STAFF REPORT AND RECOMMENDATION ON APPEAL

APPEAL NO.: A-6-LJS-98-169

APPLICANT: Scott Moncrieff

PROJECT LOCATION: 6102 Camino de la Costa, La Jolla, San Diego, San Diego County. APN 357-141-04

EXHIBIT NO. 4

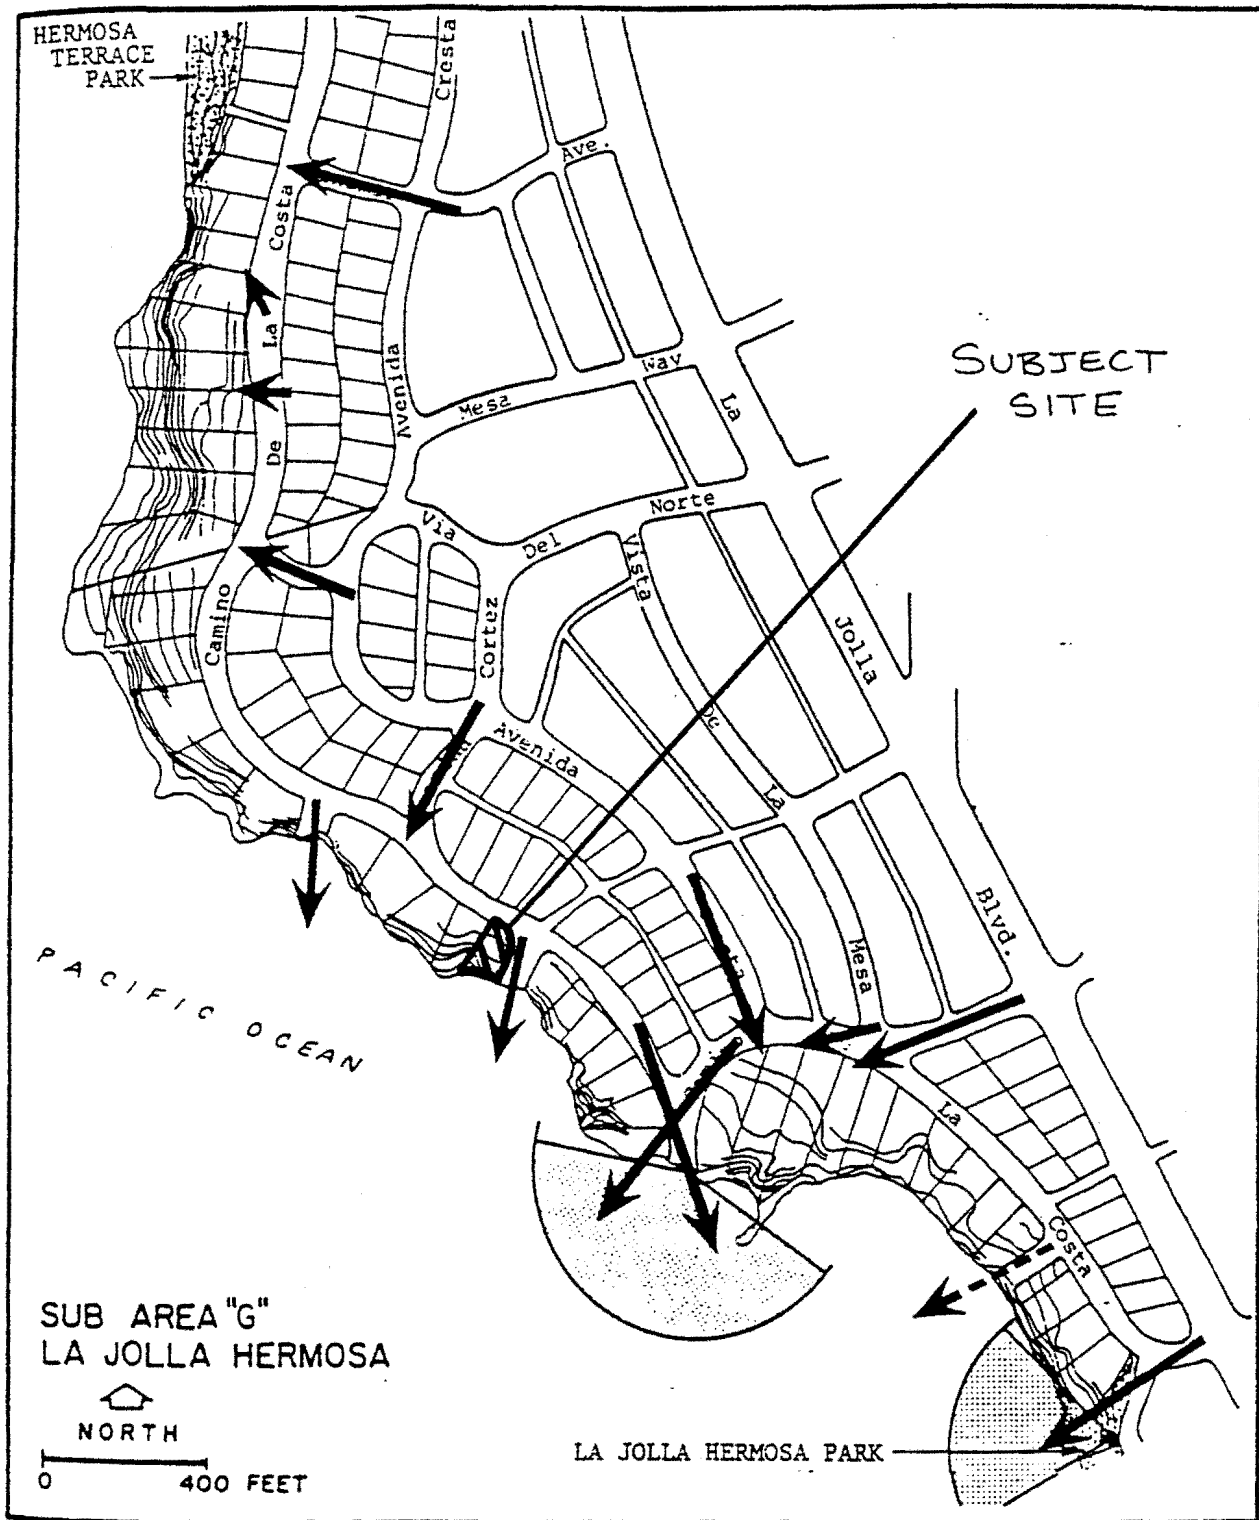
NOTE: LOW RETAINING WALL TO BE REMOVED WHEN
OPEN FENCING IS RELOCATED TO LOT LINE

EXHIBIT NO. 5
APPLICATION NO.
A-6-LJS-98-169
Cross-Section of Proposed
South Side-Yard Wall
California Coastal Commission

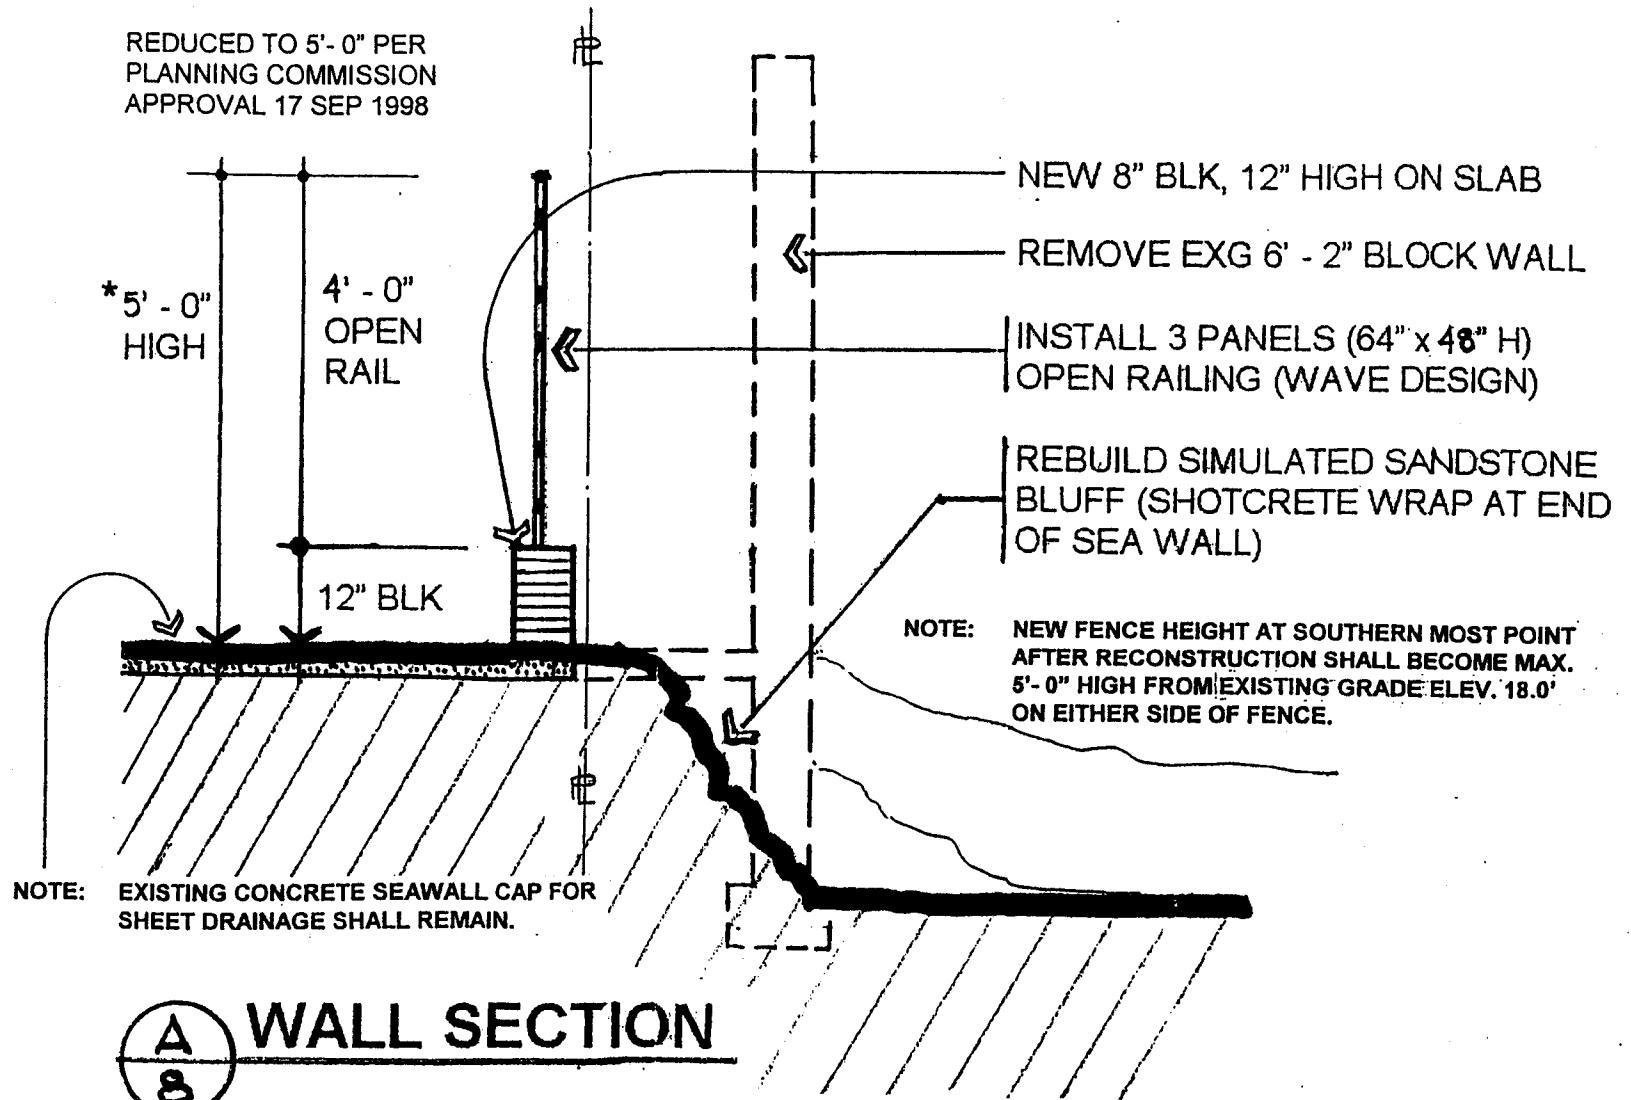
REDUCED TO 5'-0" PER
PLANNING COMMISSION
APPROVAL 17 SEP 1998
